Modification Guide for Winchester Super Model 1 for LPGWorks Shell Catcher

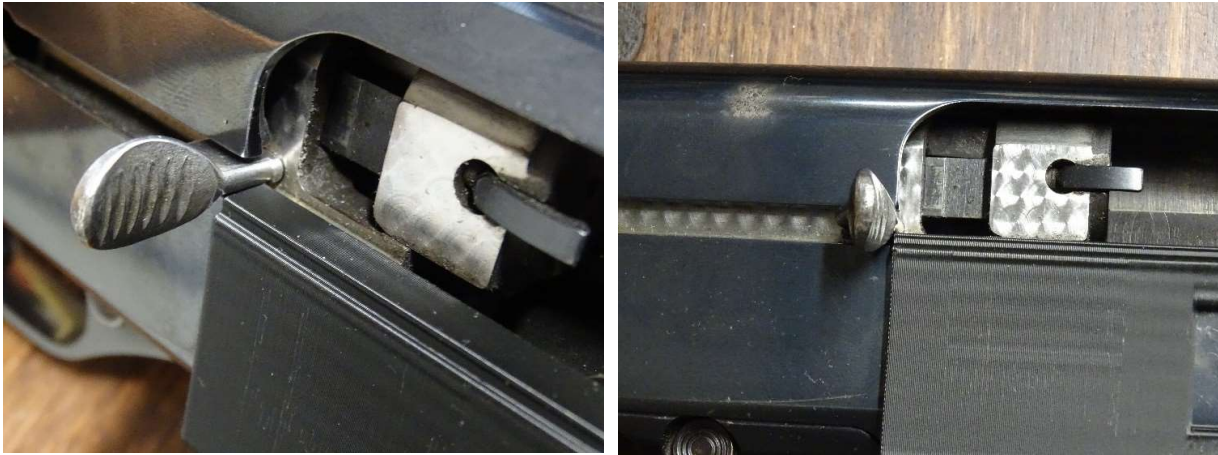
Due to the location of the charge handle on the Winchester Super X Model 1, there isn't enough clearance between it and the required height of the shell catcher as shown below.

The charge handle will need to be modified as follows.

Remove approximately $\frac{1}{64}$ (.0196) of an inch / .5mm of material in the area marked on the charge handle in black below.
